**Transmittal
Additional Information in Support of
LTCP Evaluation
1650 65th Street
Emeryville, California
Fuel Leak Case No. RO0000440
Geotracker Global ID T0600100511**

SUBJECT: Additional Information in Support of LTCP Evaluation
1650 65th Street
Emeryville, California
Fuel Leak Case No. RO0000440
Geotracker ID T0600100511

PROJECT NO.: 1211.001.03.002

ROSE DIAGRAM - HISTORICAL SHALLOW GROUNDWATER FLOW DIRECTION

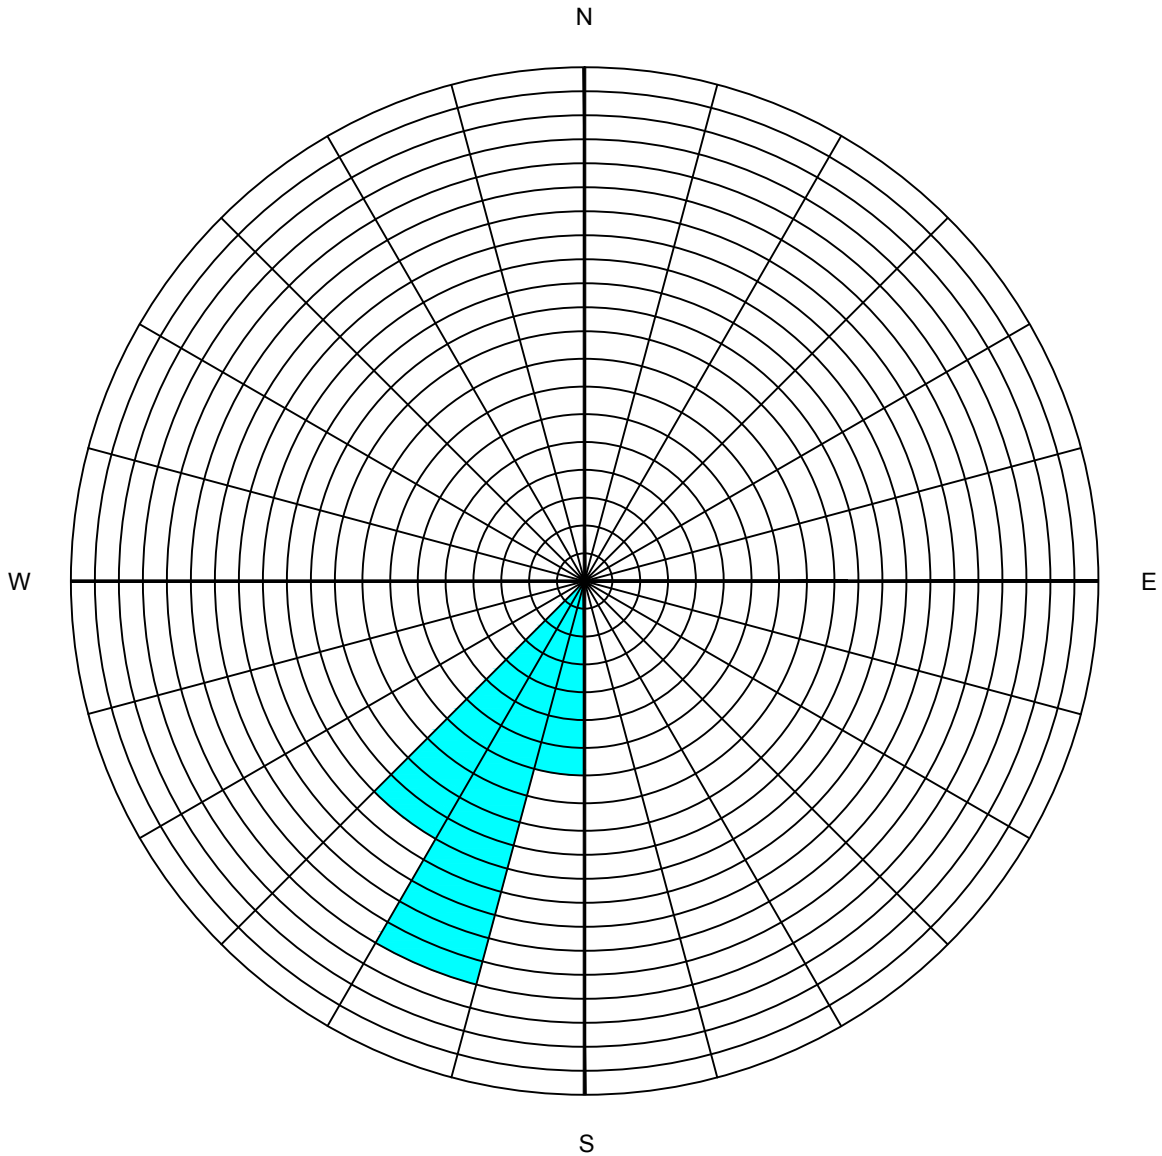
Based on our discussions, PES reviewed historical groundwater monitoring data to assess the potential for the presence of the petroleum hydrocarbons in well MW-8 due to variance in groundwater depth or flow direction. A plot depicting historical depth-to-water measurements at well MW-8 over time is presented in Appendix C. As indicated in the attached plot, groundwater levels have been generally stable over time. Based on the monitoring network groundwater elevations measurements, groundwater flow direction in the vicinity has also been consistently to the southwest. A rose diagram indicating estimated historical groundwater flow directions at the site is presented in Appendix D. The rose

diagram was compiled from groundwater elevation contour maps from available historical monitoring reports prepared over a 20-year period between 1992 and 2012.

Due to the presence of a continuous levee located approximately 250 west of the site (upon which Interstate Highway 80 was constructed), tidal influence from San Francisco Bay does not appear to significantly affect groundwater flow direction or elevation.
